ADDENDUM NO. 01

November 7, 2025

To Drawings and Specifications dated October 24, 2025

Reynolds Elementary School Maintenance Improvements
Spring Independent School District

1 SITE PLAN

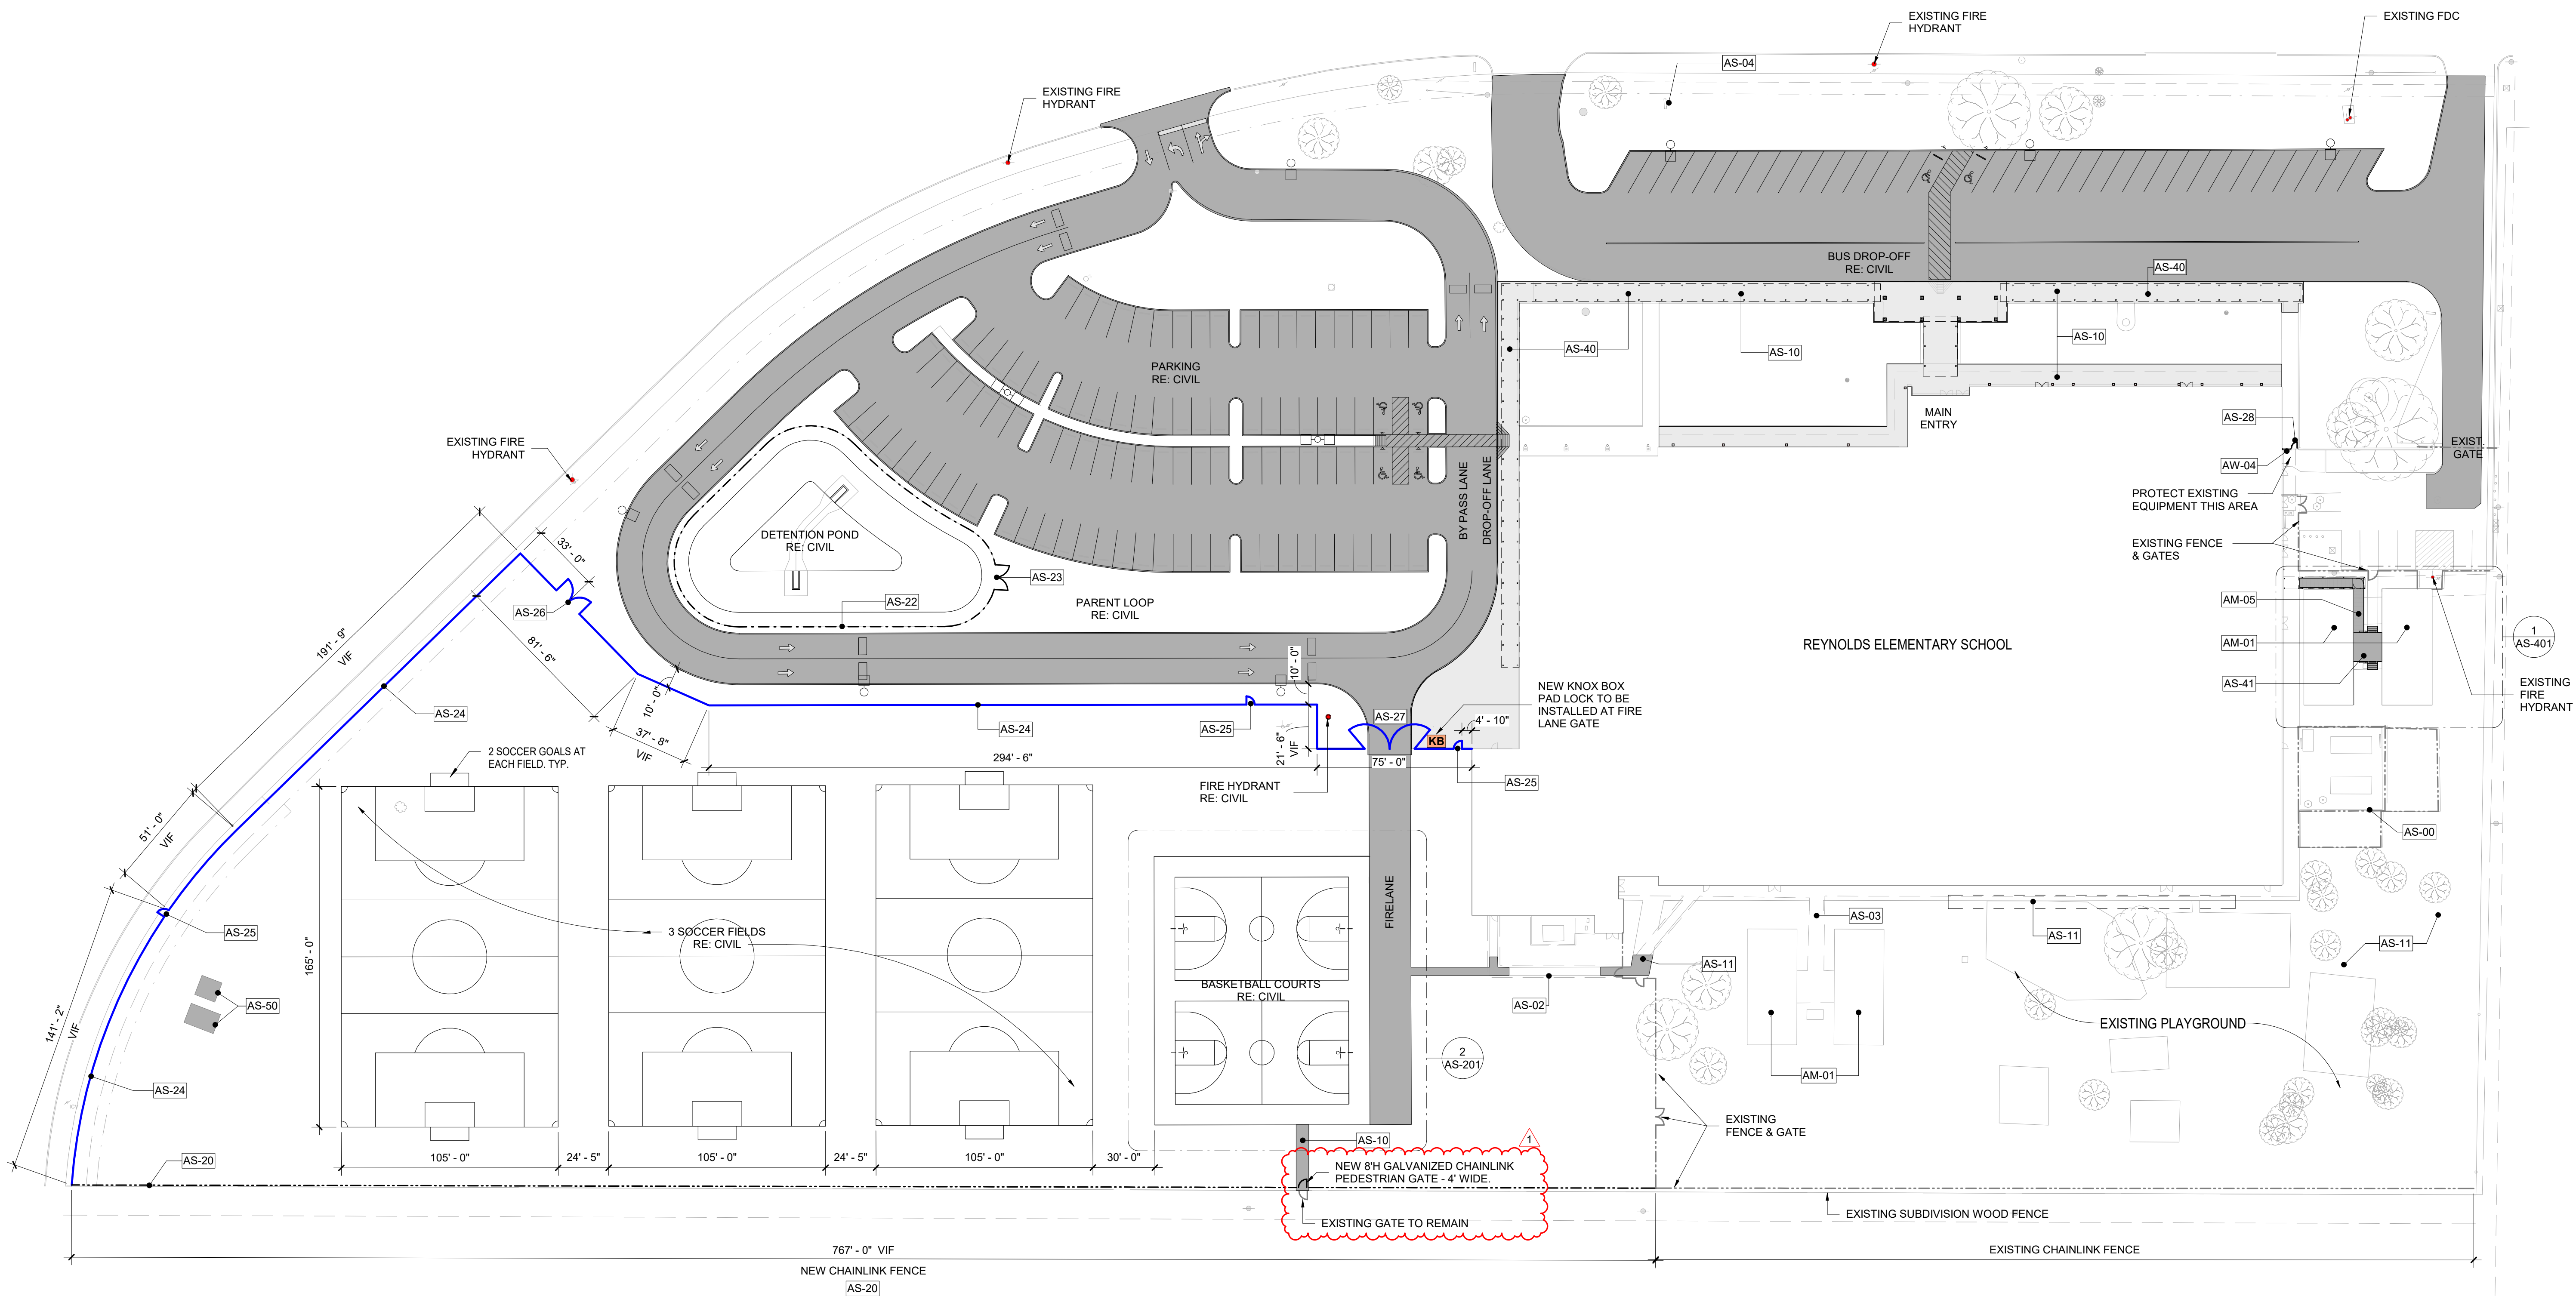
- Item No. 24 Sheet AS-200, Site Plan
A. Discard and replace with enclosed adding chain-link pedestrian gate in front of existing gate.
- Item No. 25 Sheet AS-201, Site Details

6 CHAINLINK FENCE - PEDESTRIAN GATE ELEVATIONS
1/2" = 1'-0"

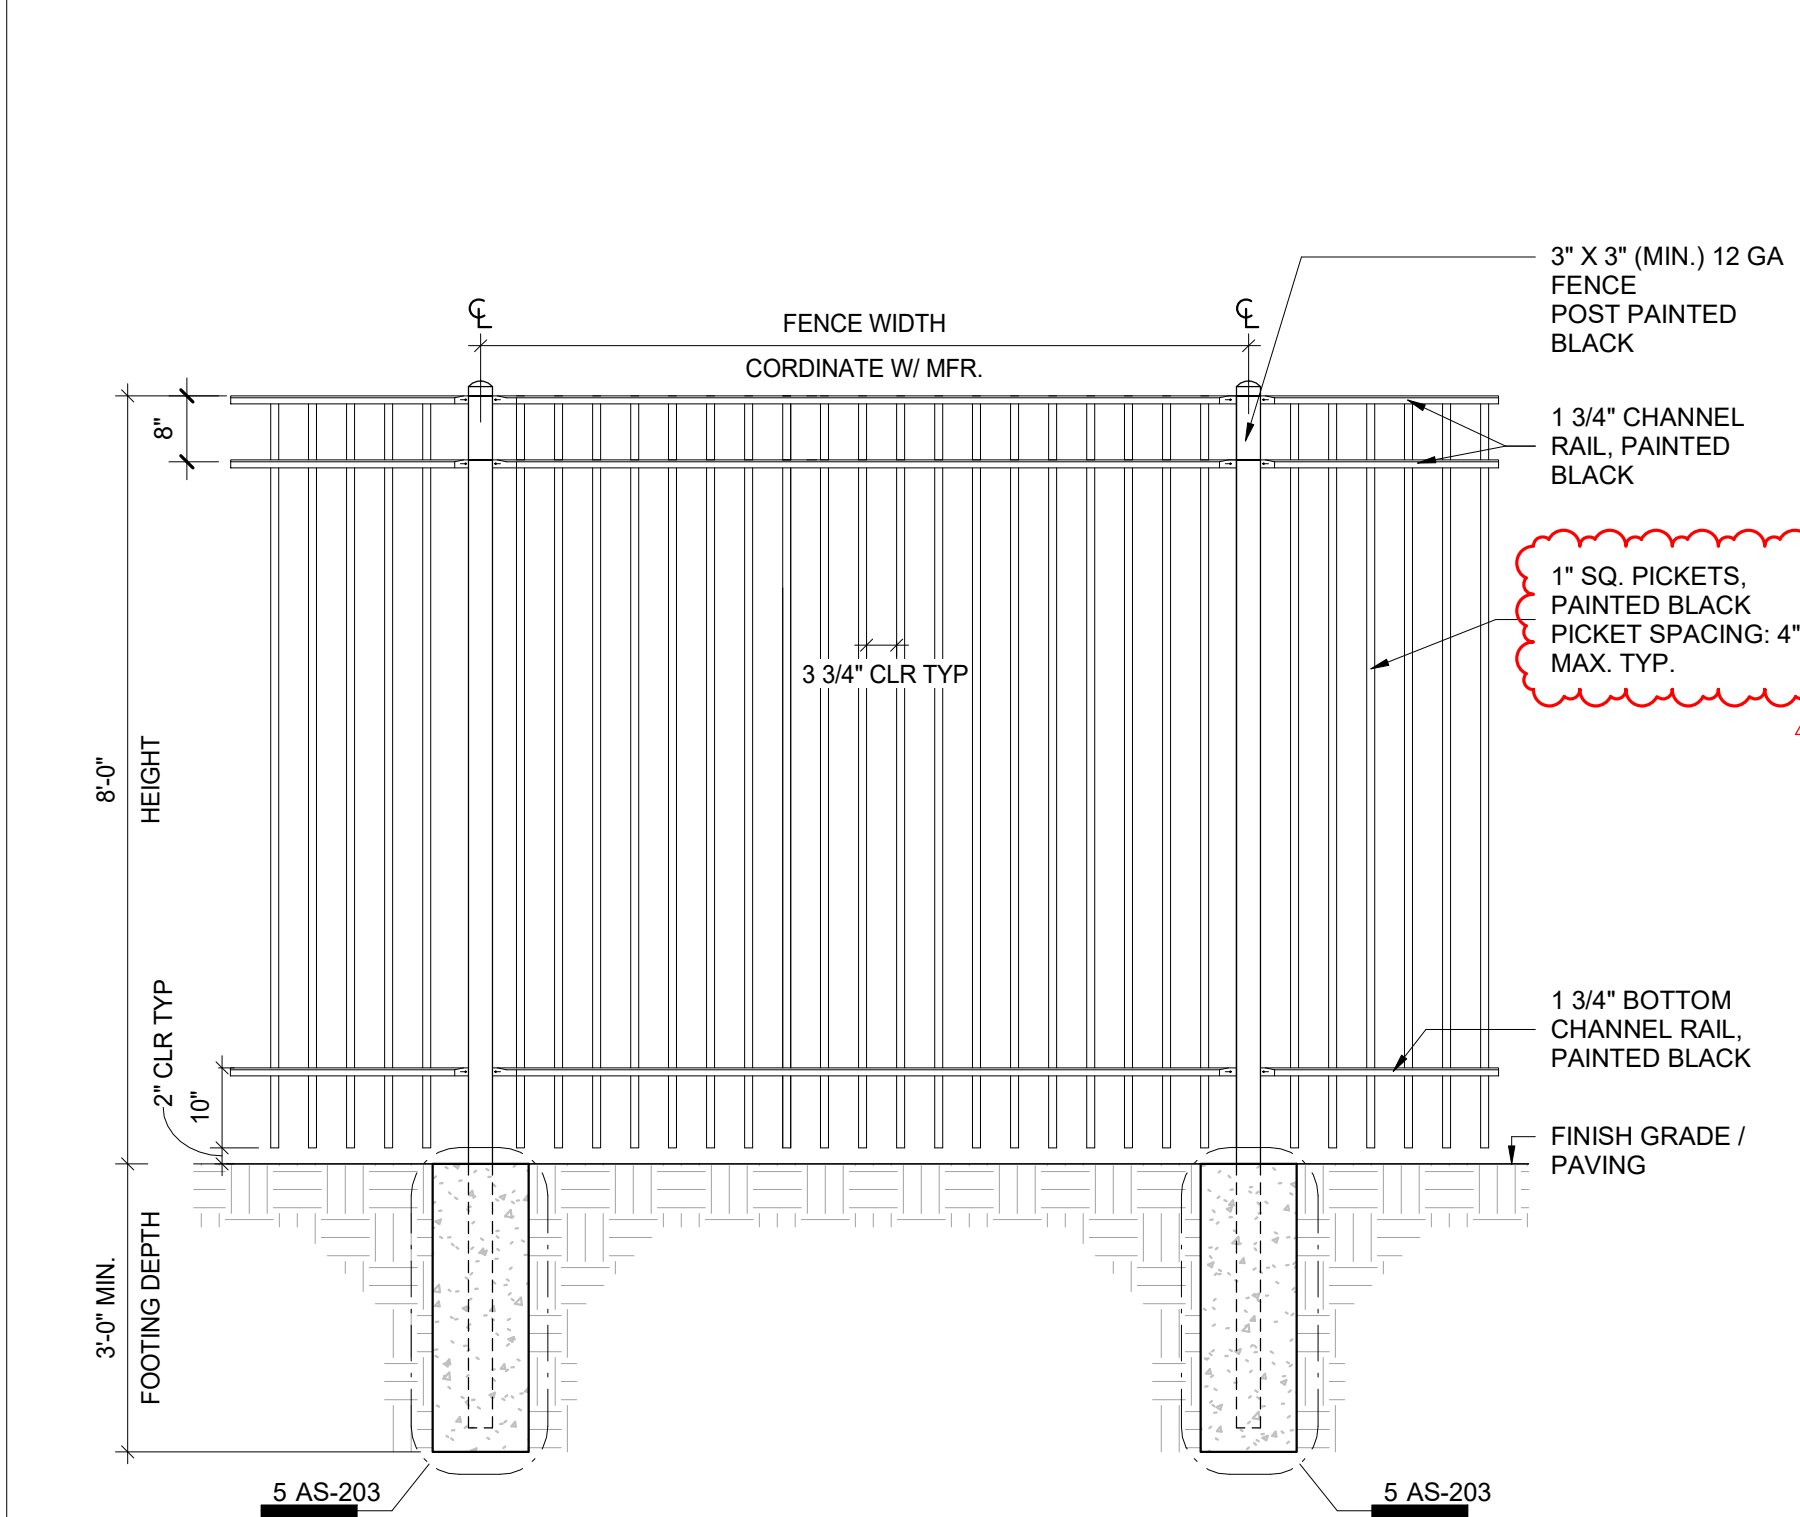
A. Discard and replace with enclosed adding chain ling gate details.
- Item No. 26 Sheet AS-202, Site Details
A. Detail 6, revised gate post to be 6"x6".

PARTITION TYPE S-1 – TYP. ALL RR CHASE WALLS
NTS

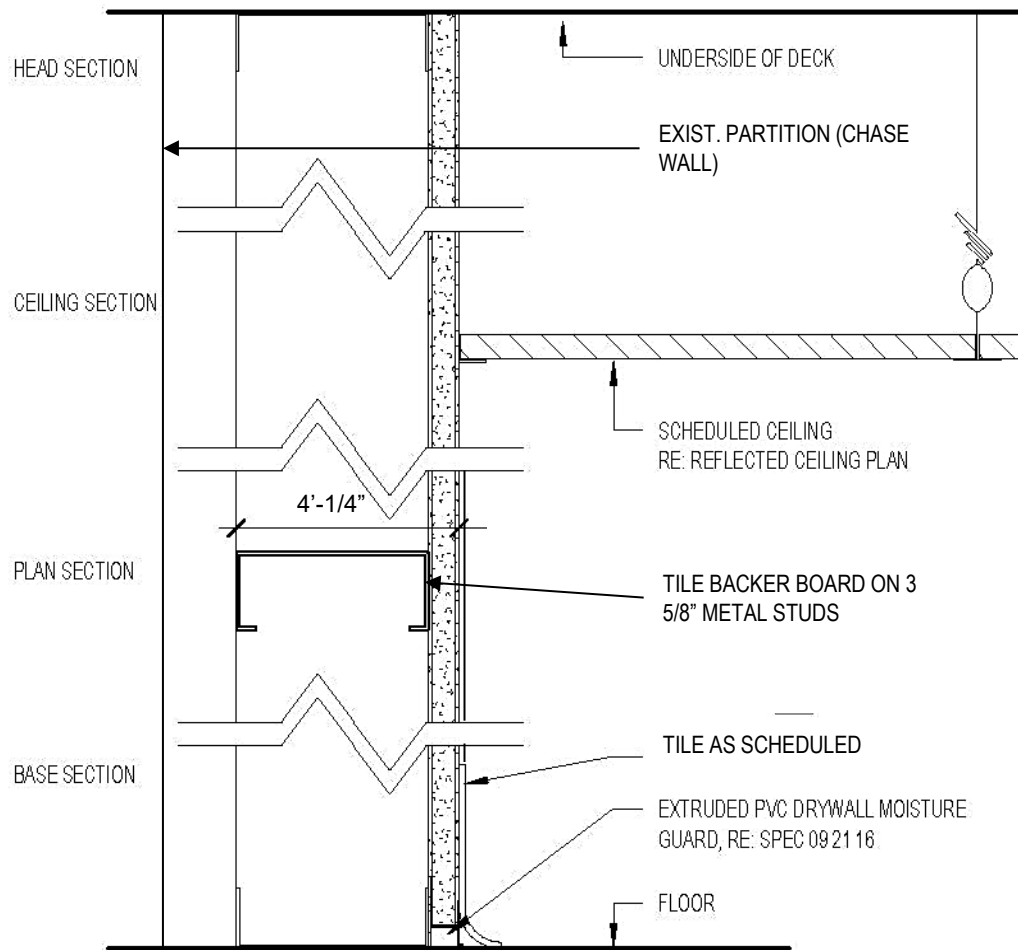
- Item No. 28 Sheet A-401, Enlarged Restroom Plans
A. Add attached partition type S-1, typical partition for all restroom chase walls.
B. Detail 24, Kitchen RR K107

1 ELECTRICAL COMPOSITE PLAN
Scale: 1/16" = 1'-0"

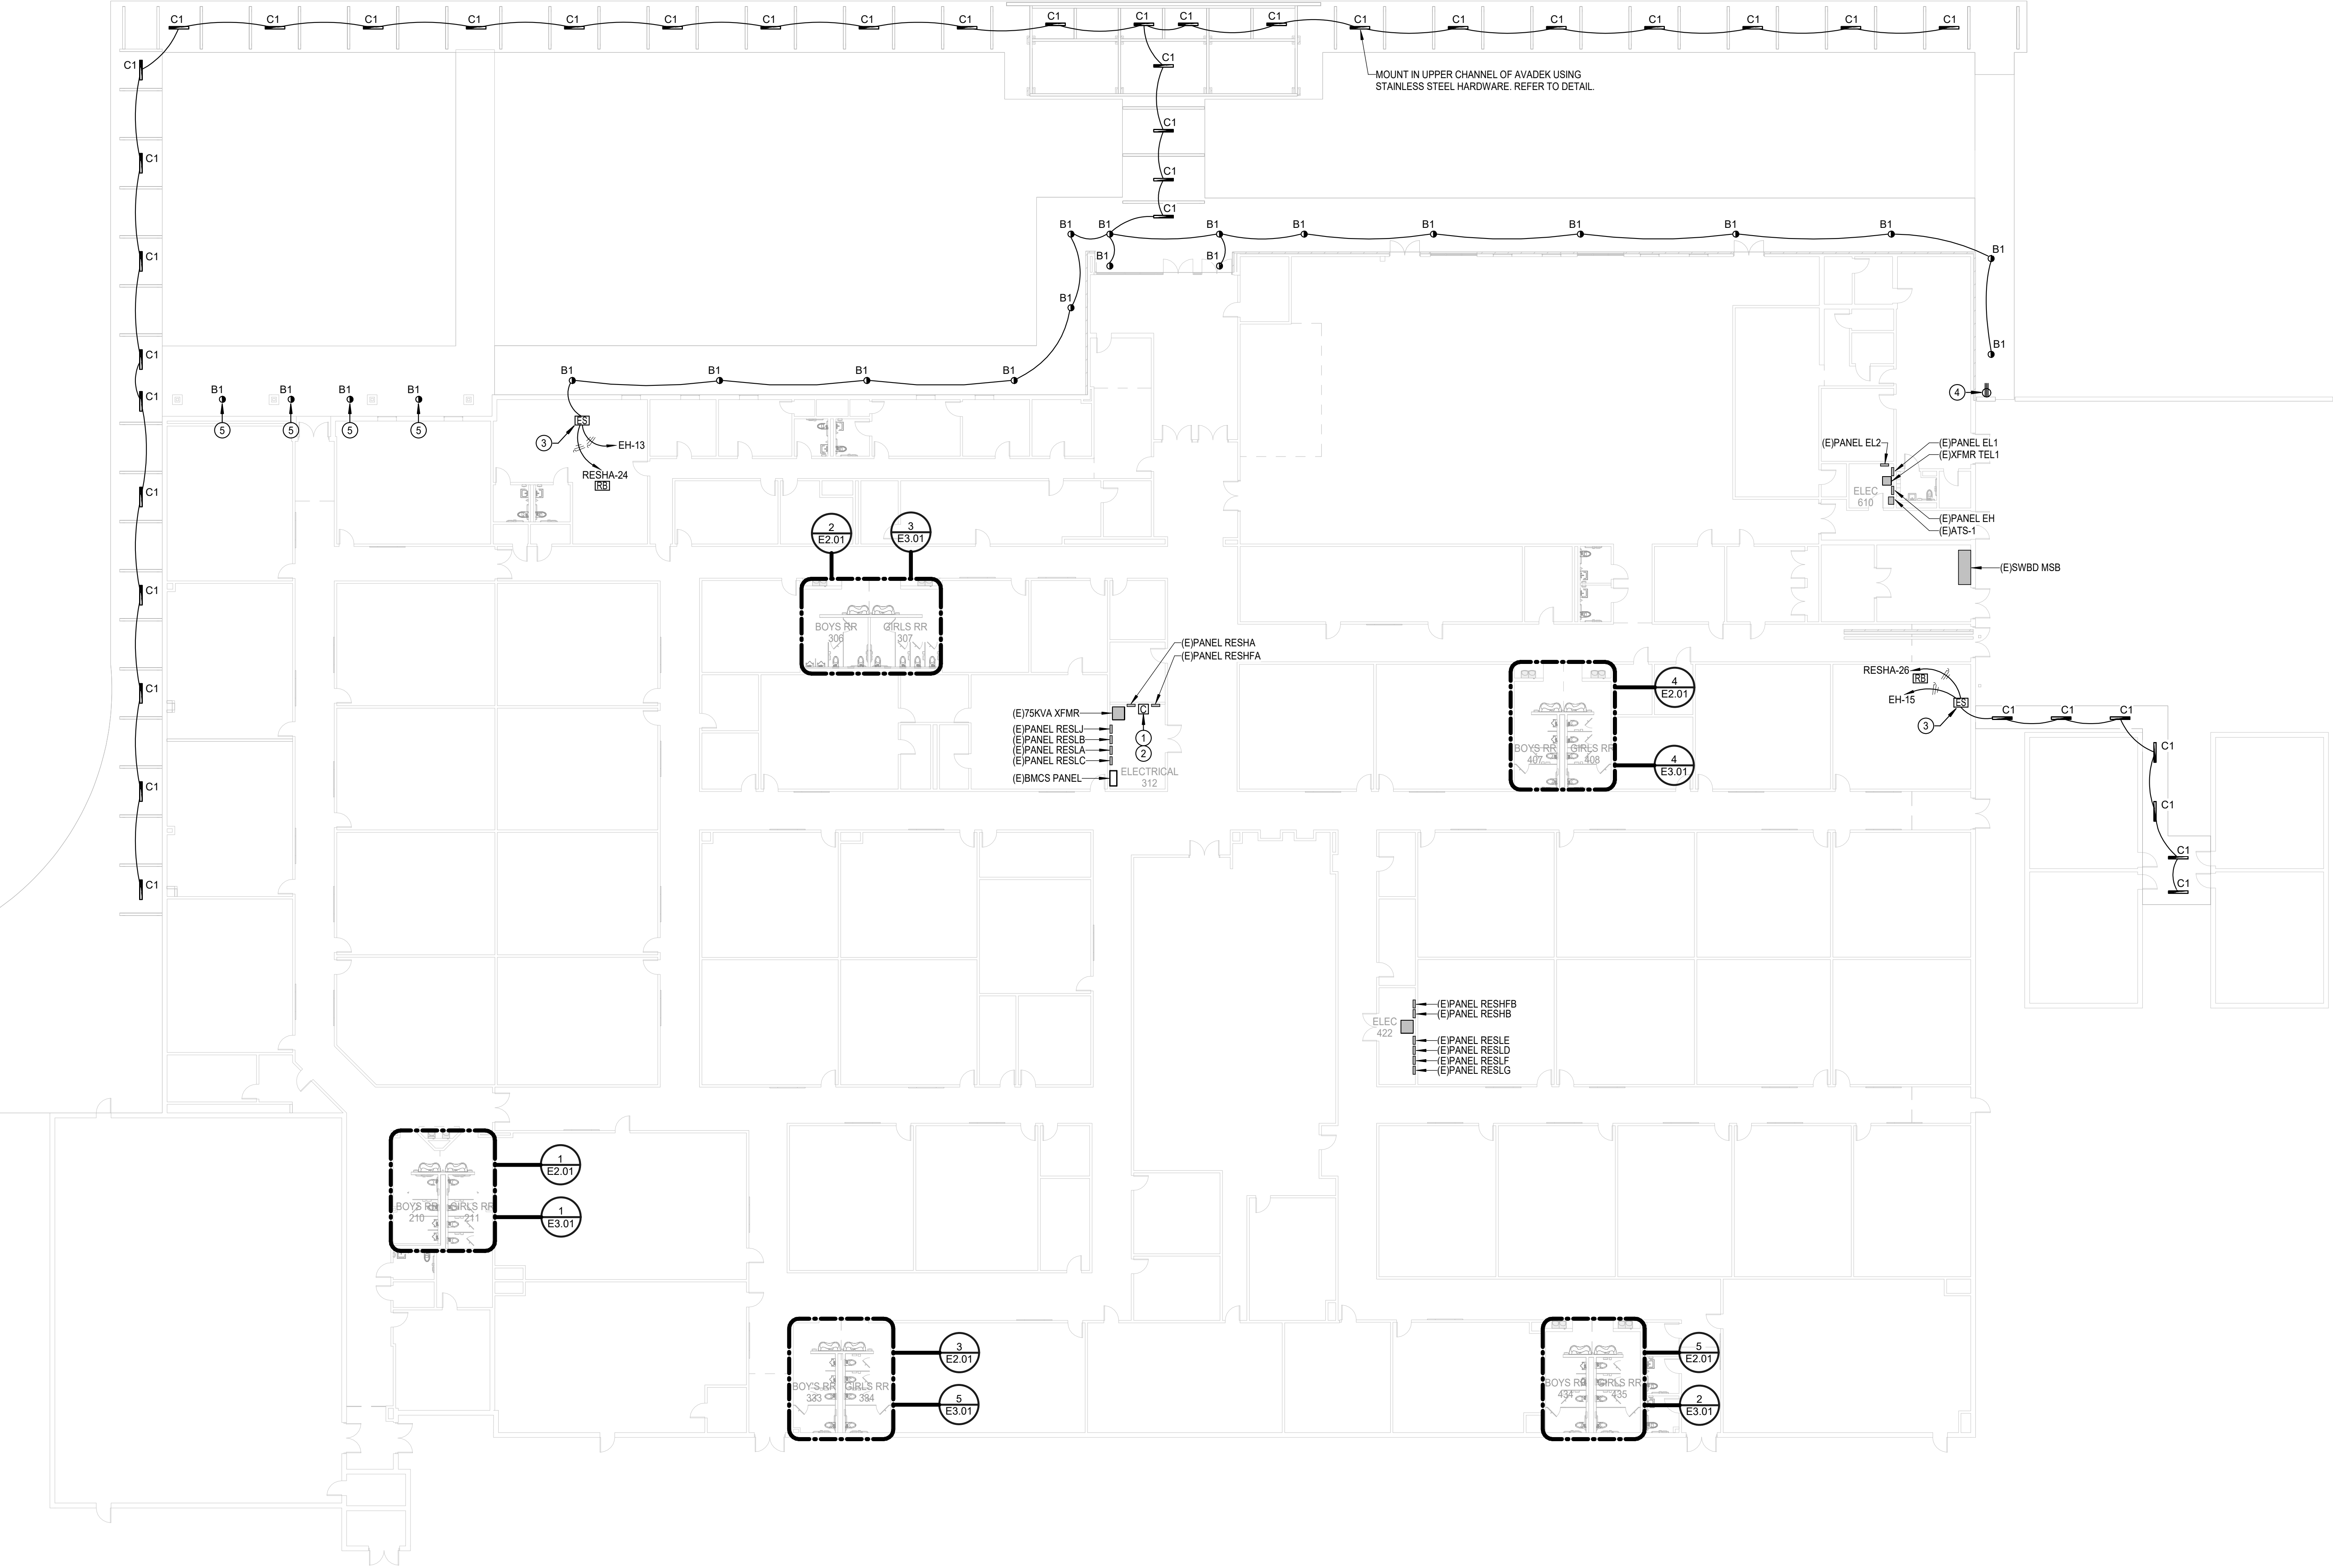
- Item No. 31 Sheet E1.01, Electrical Composite Plan
A. Discard and replace with enclosed.
a. Revise keyed note #2, note shall read:
"PROVIDE NEW LIGHTING CONTACTORS 'C1' AND 'C2':
• C1 - CANOPY LIGHTS, RE-USE EXISTING BMCS CONTROL POINT.
• C2 - PARKING LOT LIGHTS, RE-USE EXISTING BMCS CONTROL POINT."
- Item No. 32 Sheet E2.01, Electrical Plans - Demolition
A. Discard and replace with enclosed.
a. Revise keyed note #2, note shall read: "DISCONNECT AND REMOVE ALL ELECTRICAL TO EXISTING HAND DRYER, AND ASSOCIATED CONDUIT/WIRE BACK TO SOURCE. RE-LABEL EXISTING CIRCUIT BREAKER AS 'SPARE'."
- Item No. 33 Sheet E3.01, Electrical Plans – New Work
A. Discard and replace with enclosed.
a. Revise keyed note #2 and #3, note shall read: "NOT USED."
b. Delete electrical work for electric hand dryers.
